Traffic Analysis Review:

Four Corners Intersection Study

DRAFT Report

PRISM Engineering reviewed the **TETAP Marin County Panoramic Highway at Four Corners Intersection Improvement Feasibility Study, June 30, 2003**, completed previously for Marin County and the MTC. Specifically, we reviewed only Alternatives 2 and 3 of that study pertaining to revised channelized striping or raised curbs for the intersection to better define edge lines of the traveled way. These TETAP alternatives kept existing traffic controls in place (free flows on Panoramic Highway approaches, and stop sign control of the side streets Muir Woods Road and Sequoia Valley Road). We did not review the roundabout alternative (Alternative 1) in that report as instructed by County staff, since it was deemed currently infeasible due to lack of sufficient funds to build, as well as lack of available right-of-way to properly and safely construct (since retaining walls, etc. would likely be necessary due to steep slopes and topography constraints immediately surrounding the intersection).

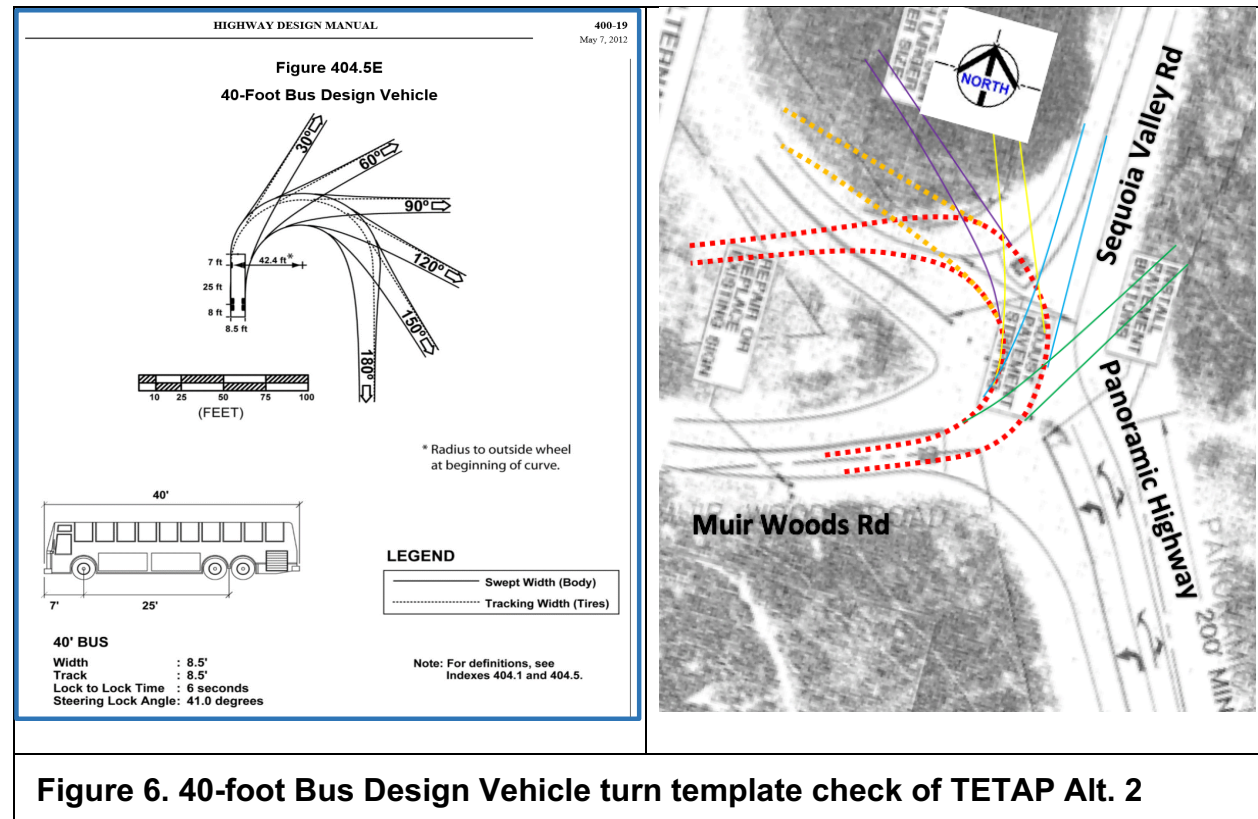
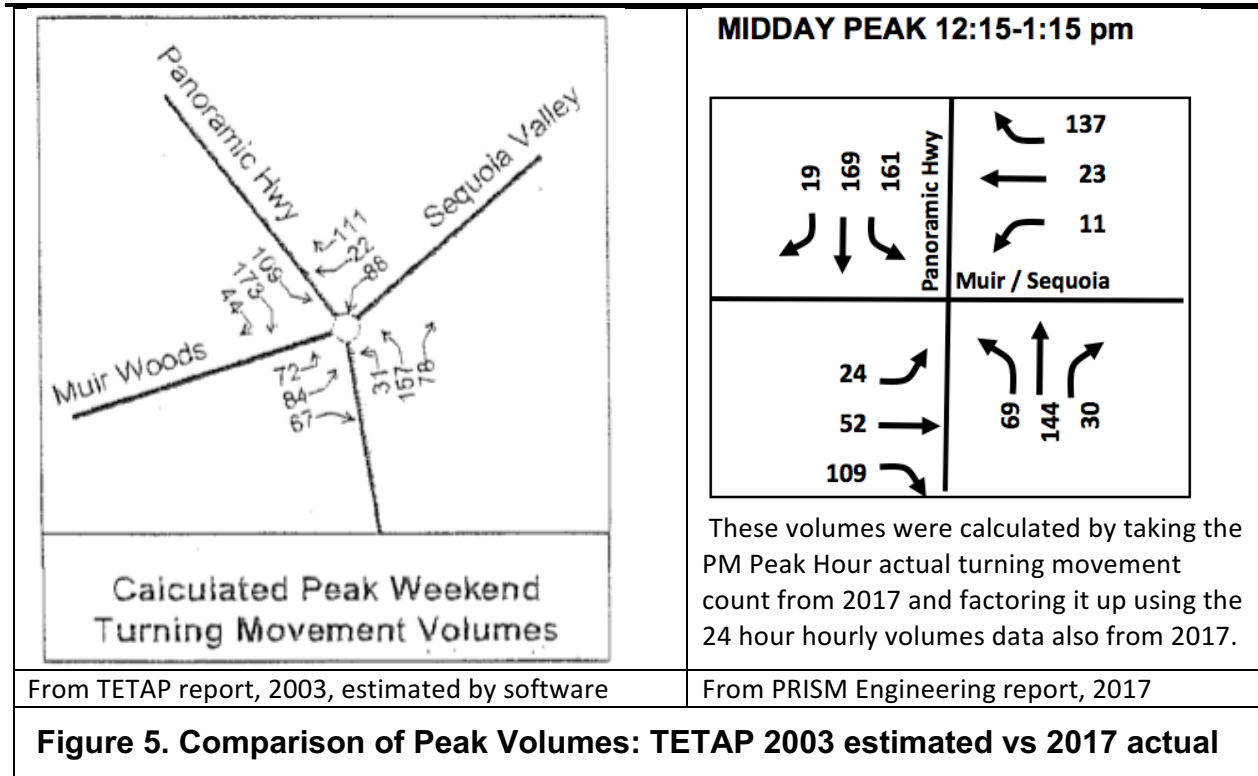
- 1) The traffic analysis procedures used were HCM 2000 methodologies. The manual worksheets contained in the appendix of the TETAP Report show very similar results to the output from Synchro 9 calculated in this report. Figure 5 shows a comparison of the software generated turning movement volumes from the TETAP report in 2003 (they did not have actual traffic count data at the time and these were estimates based on a software balancing program), and the actual accounts taken by PRISM Engineering in July 2017.

- a. The results of peak traffic in the TETAP report yielded LOS D results (30.5 secs delay avg) for the side street of Muir Woods Road, the worst approach.
 - b. In the PRISM Engineering calculation for midday peak volumes based on actual counts, the numbers differ slightly (see Figure 5) but the results are very similar with LOS D for the side street Muir Woods Road EB approach which is currently at LOS D with 27.3 seconds of average delay.
- 2) This is essentially the same result. This is based on both analyses using the same methodology, the Highway Capacity Manual 2000 methods. PRISM Engineering utilized the Synchro 9 software to make this calculation. The TETAP calculation is contained in the appendix of this report.

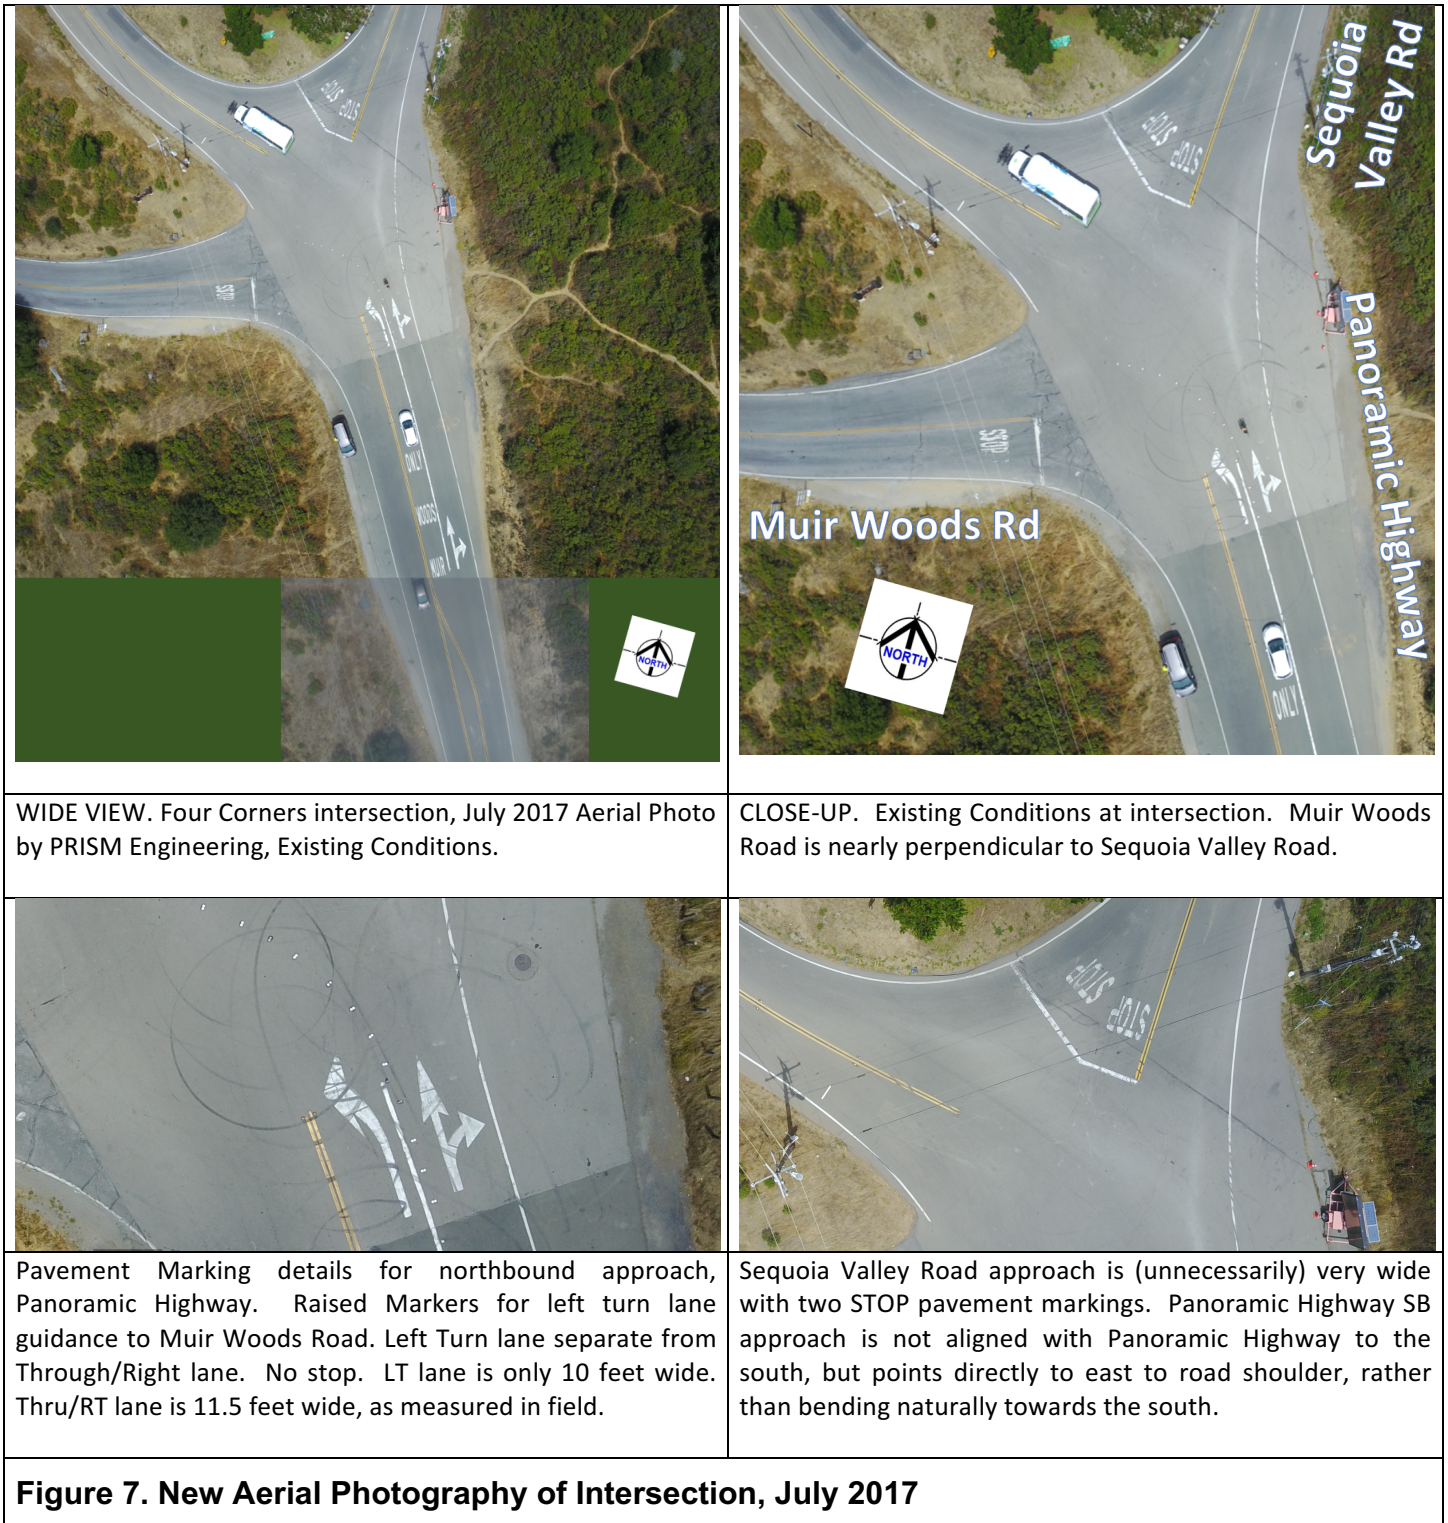
- 5) Turning templates were laid on to the TETAP Alternative 2 and 3 design concepts to determine the ability for a 40-foot vehicle to make a left turn out from Muir Woods Road to go northbound on Panoramic Highway. In our check of left turn lane alignments for each of the four intersection approaches on the TETAP design, we utilized the Highway Design Manual (HDM) 40-foot bus design vehicle turning template shown from Figure 404.5E. Figure 6 shows this HDM template (lower left corner) as well as *how* it was applied to the Alternative 2 design layout. The template showed that this movement was not possible without encroaching upon lanes or approaches of opposing traffic. In Figure 6 the dashed red and orange lines show that for the 40-foot design vehicle, the front wheels would need to cross into the Sequoia Valley WB approach (unacceptable), as well as leave the pavement on the north side of the intersection. Of course, this vehicle could make a tighter turn but not without encroaching nearly completely on the southbound Panoramic Highway lane of the SB approach. This is unacceptable, and a flaw in the design concept.

Disadvantages of Alternative 2 or 3 Design Concept. The proposed alignment of striping for the intersection approaches in both of these TETAP alternatives did not optimize sight distance and turning movement conditions, especially for large vehicles. This was especially true for the eastbound Muir Woods Road approach, where there was still a 60° angle remaining between the Muir Woods Road approach centerline and Sequoia Valley Road approach centerline.

These side street centerlines should be as parallel and collinear as possible. The intersection approaches could have been squared up more, but as it stands, Alternatives 2 and 3 do not pass the design vehicle turn test as defined in the Highway Design Manual, Figure 404.5E, and illustrated in Figure 6. In addition, these alternatives left in place the existing traffic control as stop sign control for side streets and no stop for the Panoramic Highway (TWSC). Because the intersection remains nonstandard in design layout (Sequoia Valley Road approach striping remains significantly skewed to the Panoramic Highway), the skewed approach would contribute to driver confusion, cause instances of indecision or hesitation for some drivers entering the intersection, even when they have the right-of-way (such as drivers on Panoramic Highway where there is no stop sign control). It was observed by aerial video during the midday peak hour, where drivers on Panoramic Highway would come to a full stop to examine their choices of where they need to turn or whether another car is entering the intersection or not.

Recommendations. It is recommended that the County of Marin does not implement Alternatives 2 or 3 as defined in the TETAP report because of the geometric and operational disadvantages which have been explained above. These conceptual designs do not significantly improve over the existing condition, and do not improve level of service or safety.
